46838 TRIGGER KIT ASS'Y.

FORM 2320-2

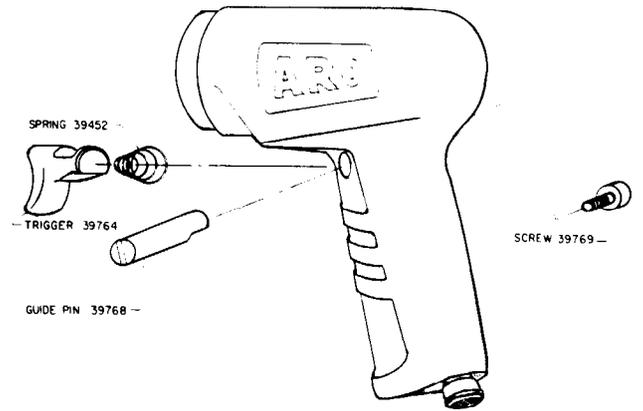
When replacing the old style steel Trigger with the new style plastic Trigger, use the new style steel Guide Pin (39768) which is slotted on large end to receive a blade type screwdriver. It will be necessary to hold the steel Guide Pin from turning, using a blade type screwdriver, to prevent damaging the plastic Trigger while tightening the Locking Screw (39769) with a hex type wrench.

46838 TRIGGER KIT ASS'Y.

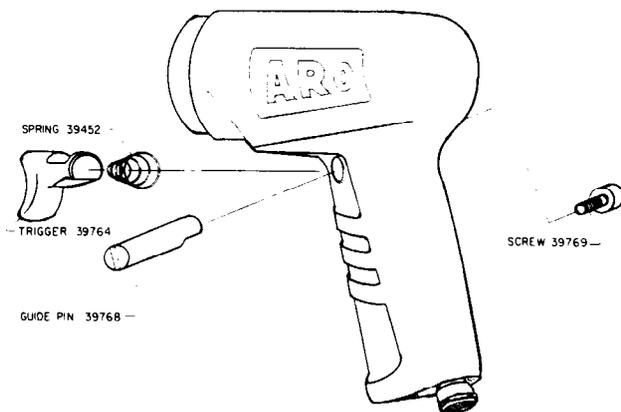
When replacing the old style steel Trigger with the new style plastic Trigger, use the new style steel Guide Pin (39768) which is slotted on large end to receive a blade type screwdriver. It will be necessary to hold the steel Guide Pin from turning, using a blade type screwdriver, to prevent damaging the plastic Trigger while tightening the Locking Screw (39769) with a hex type wrench.

46838 TRIGGER KIT ASS'Y.

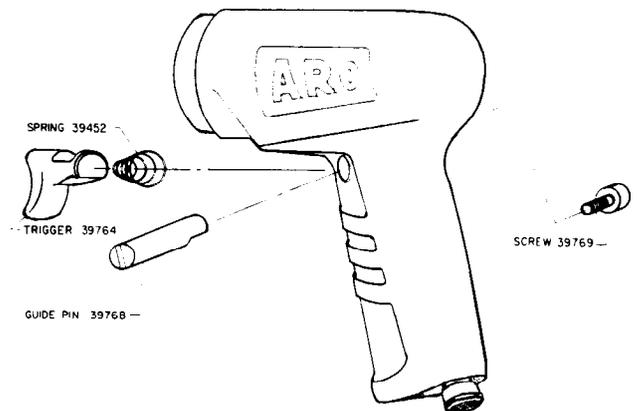
When replacing the old style steel Trigger with the new style plastic Trigger, use the new style steel Guide Pin (39768) which is slotted on large end to receive a blade type screwdriver. It will be necessary to hold the steel Guide Pin from turning, using a blade type screwdriver, to prevent damaging the plastic Trigger while tightening the Locking Screw (39769) with a hex type wrench.
